## Building Inspection Division

**DATE:** February 23, 2015  
**TO:** Plan Commission  
**FROM:** Matt Tucker, Zoning Administrator   
**SUBJECT:** Request for PD Alteration, 520-524 E. Johnson Street

# Bike parking approval next to 520 E. Johnson

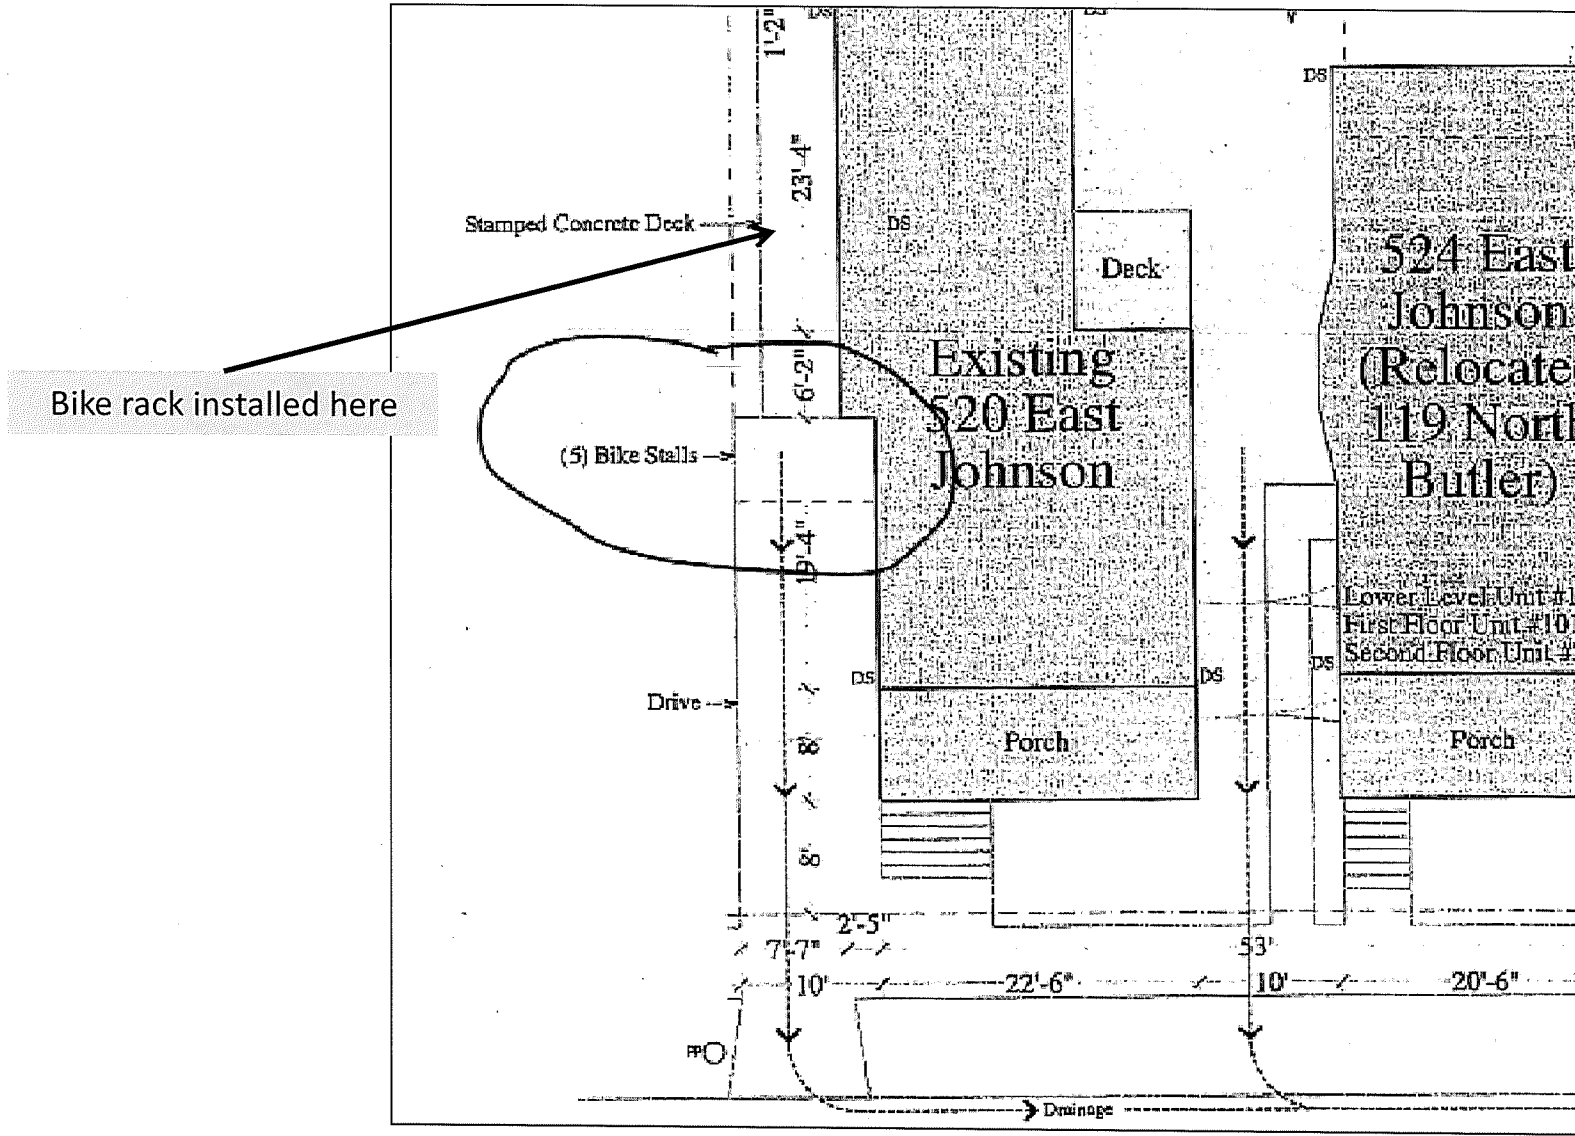
The bike parking access issue could be fixed if one added a step/steps in the retaining wall, so a person need not climb such a rise with a bike to get to the path leading to Blair Street.

Inadequate depth for parking and access, need 11', provide about 6'-7'

We also need a detail of the rack, to be sure it meets code and a re-orientation of the rack/bike parking stall. This configuration does not appear to hold bicycles correctly in their spaces, and affords little or no access around parked bikes in the rack. Rotating a rack and/or having a different rack design would accommodate the required bike parking

# Approved plans for window well installation

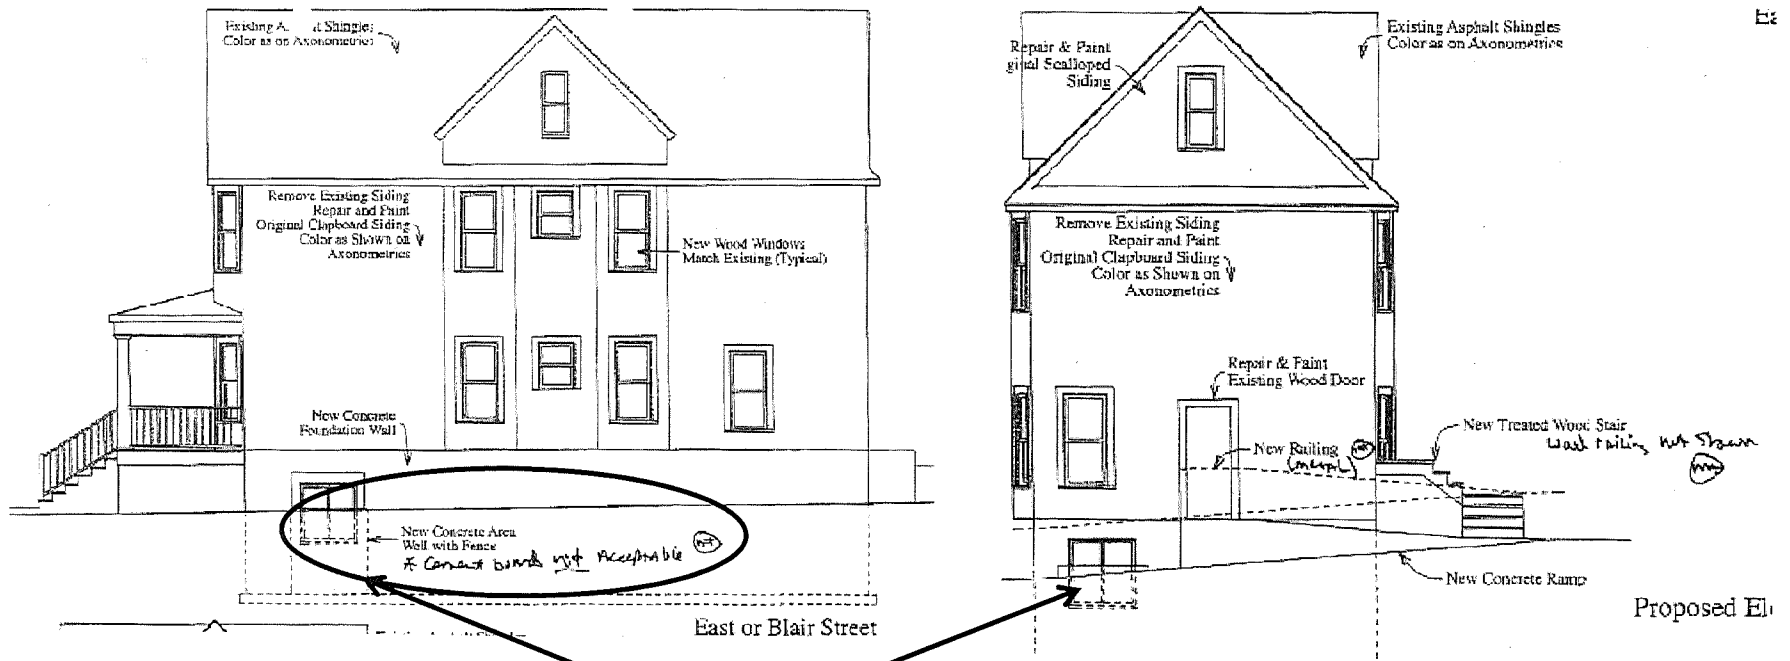
Unacceptable window wells installed here

Here is the window well at the rear (driveway):

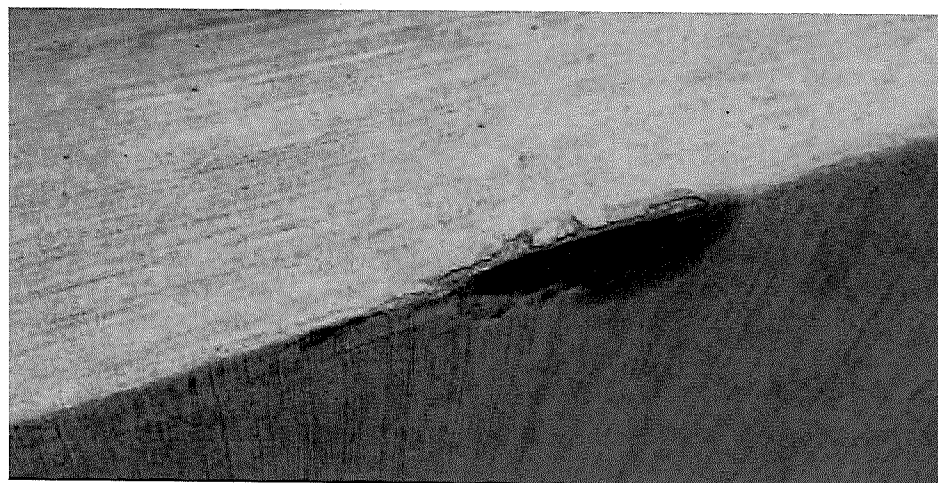
Here is a close-up of some existing damage, appear to be oxidizing/rusting and showing early sign of failure:

Here is the well by the sidewalk of N. Blair St., it already has a few marks where something hit it.

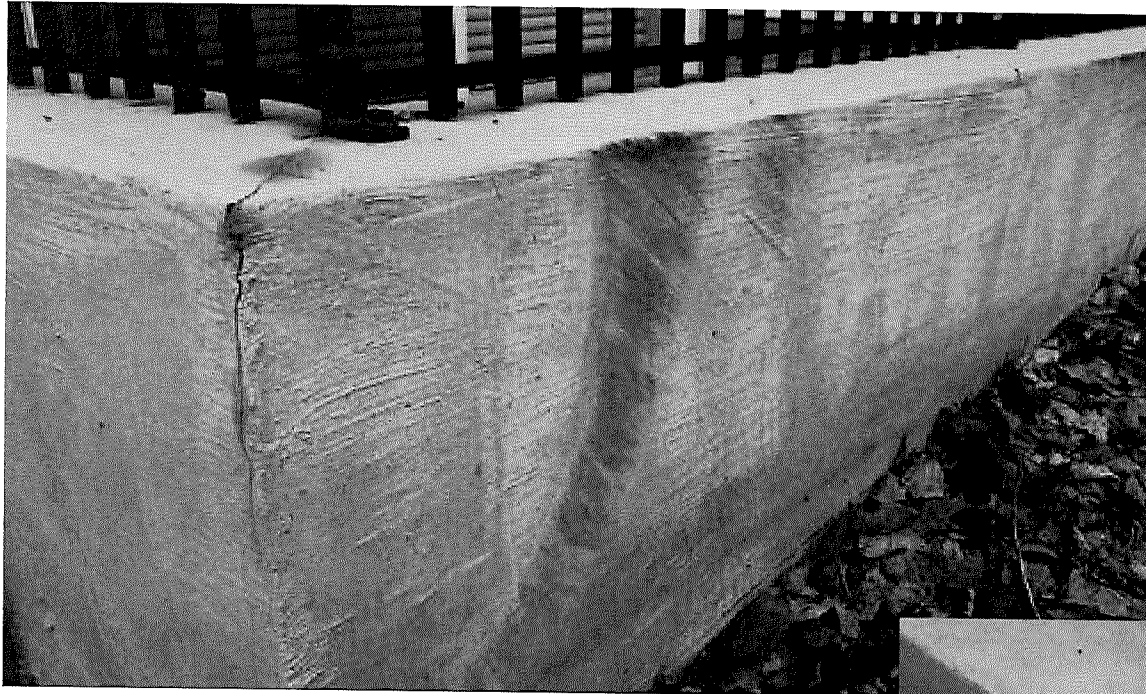
Here is a close-up of a crack that has developed on top, runs from front-to-rear, dark spots show moisture penetrating the structure. This shows failure, which is why we did not allow these installed in this location, this way. Concrete or masonry would have been acceptable.
